## ASSEMBLY SOLUTIONS

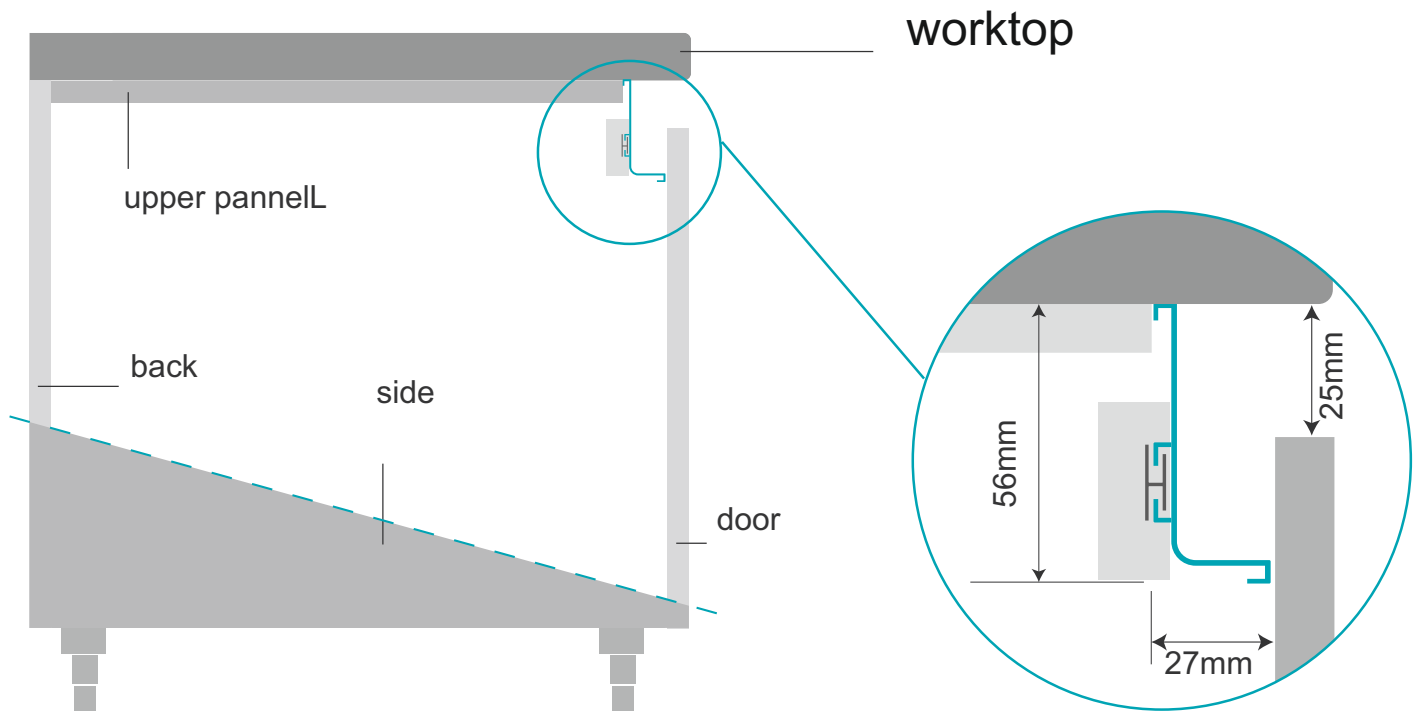
The door height to be decreased by 25mm  
The upper panel depth to be decreased by 27mm
